Discretionary Review Full Analysis

Date: February 15, 2017
Case No.: **2015-015846DRPVAR**
Project Address: **520 28th Street**
Zoning: RH-1 [Residential – House, One-Family]
40-X Height and Bulk District
Block/Lot: 6604/008
Project Sponsor: Anthony Pantaleoni, Kotas/Pantaleoni Architects
70 Zoe Street, Suite 200
San Francisco, CA 94107
Staff Contact: Elizabeth Jonckheer – (415) 575-8728
elizabeth.gordon-jonckheer@sfgov.org
Recommendation: **Do Not Take Discretionary Review and Approve as Revised**

The project proposes vertical and horizontal additions to the existing 1,200 square-foot, one-story, single-family home. Work includes a new 2-car garage at the front of the subject lot. The project has been modified since the original proposal – the two lower levels above the proposed garage have been removed and a tiered landscaped open space area is now proposed in the existing hillside. The front wall of the house will be removed and replaced with a new facade. The roof will be removed and a new second floor added.

TIEBACK PARAMETERS

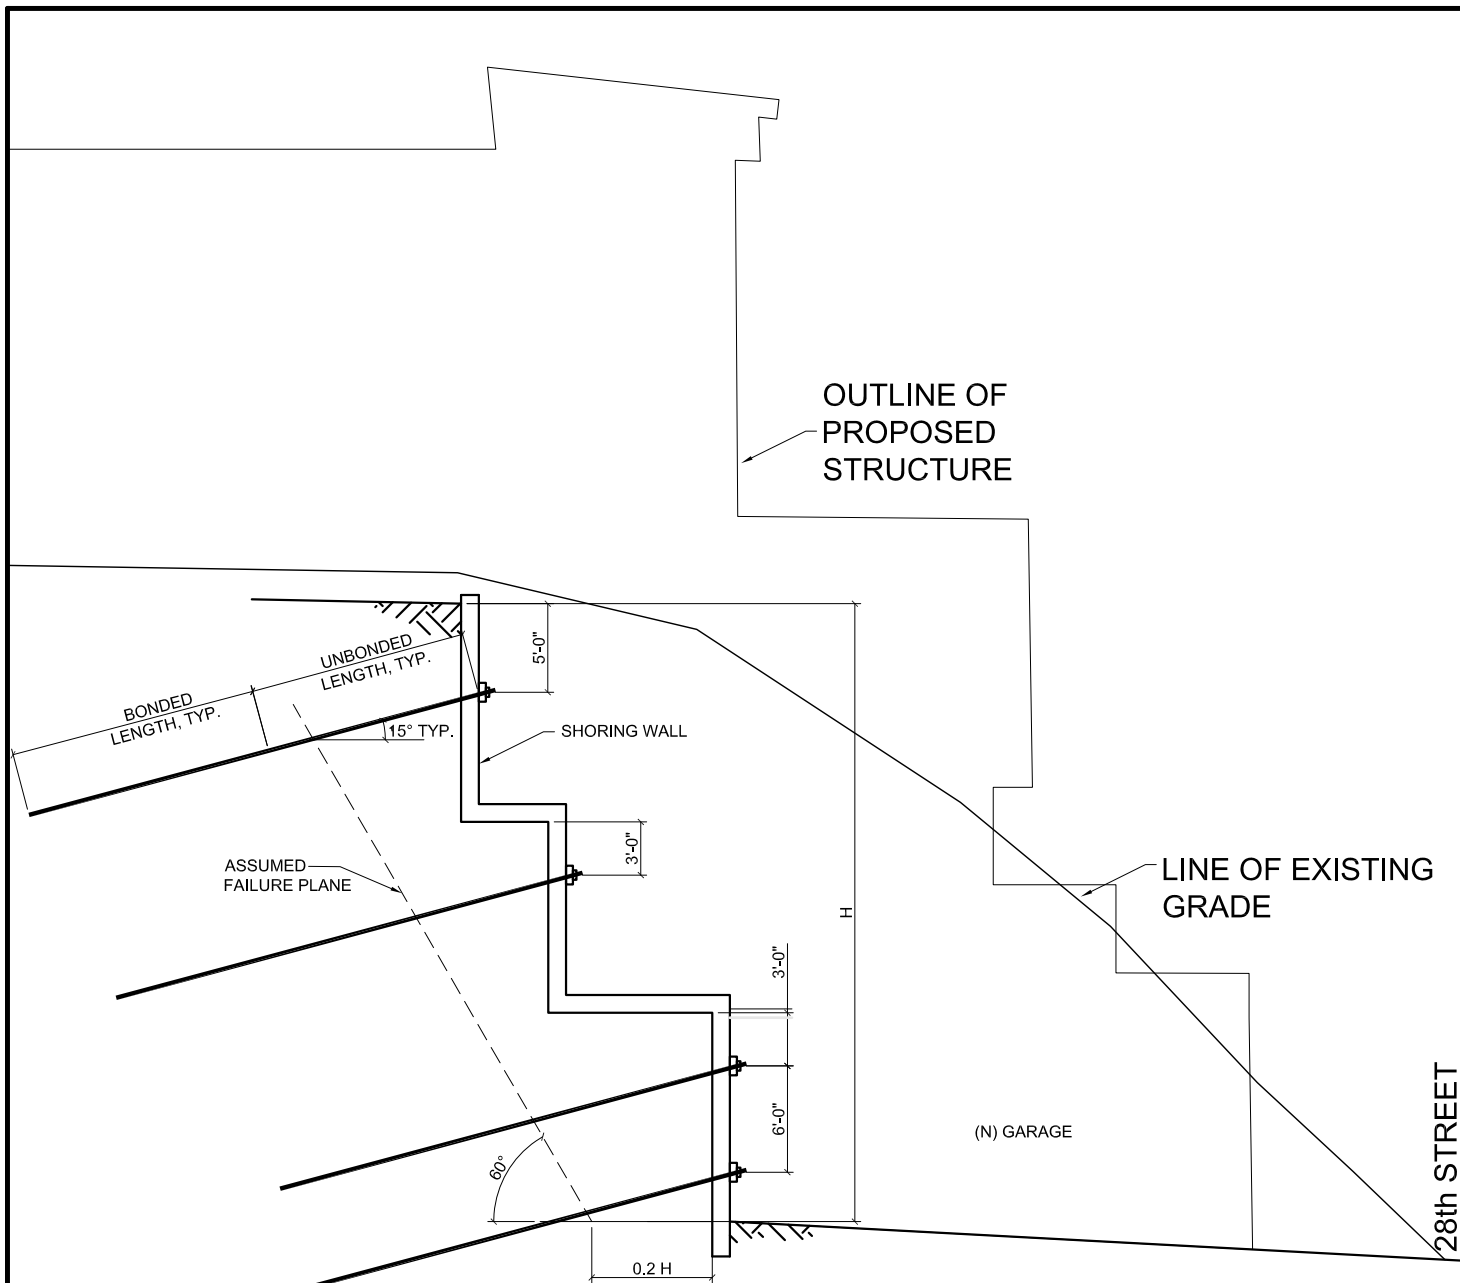
Page 8 provides design criteria for tieback anchors to have a total length of at least 30 feet, and Figure 7 shows four rows of tiebacks to retain the rear (northern) wall of the basement excavation. It is not clear if tiebacks are being proposed to support shoring along the eastern and western boundary. Based on the planned location of the basement wall, nearly the entire length of the tieback would encroach into the neighboring properties at 524 28th street and rear yards of properties on Castro. It is our

Braced pressure diagram

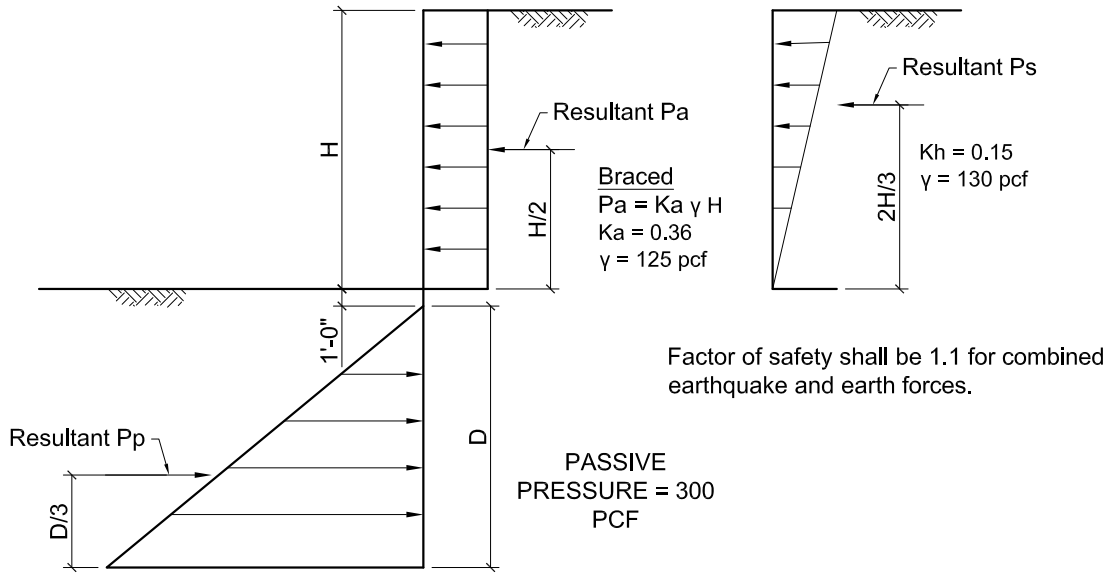
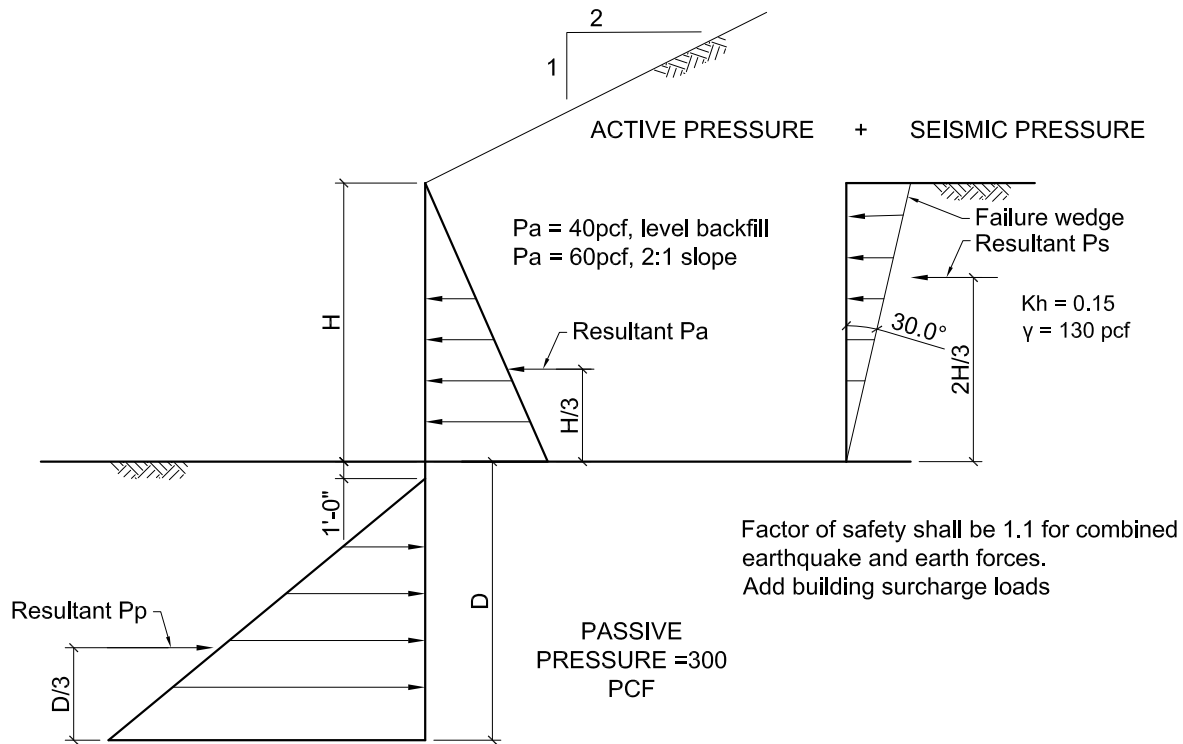
Figure 8 from the O'Conner report provides lateral earth pressure to be applied to the backside of retaining walls. There is no basis given for this seismic pressure, or how it relates to the ground motions provided in Section 5.0. It is our experience that seismic wall pressures in rock excavations is dependent on the stability of the rock mass, which is often controlled by the orientation and spacing of fractures and discontinuities. This appears to have not been evaluated.
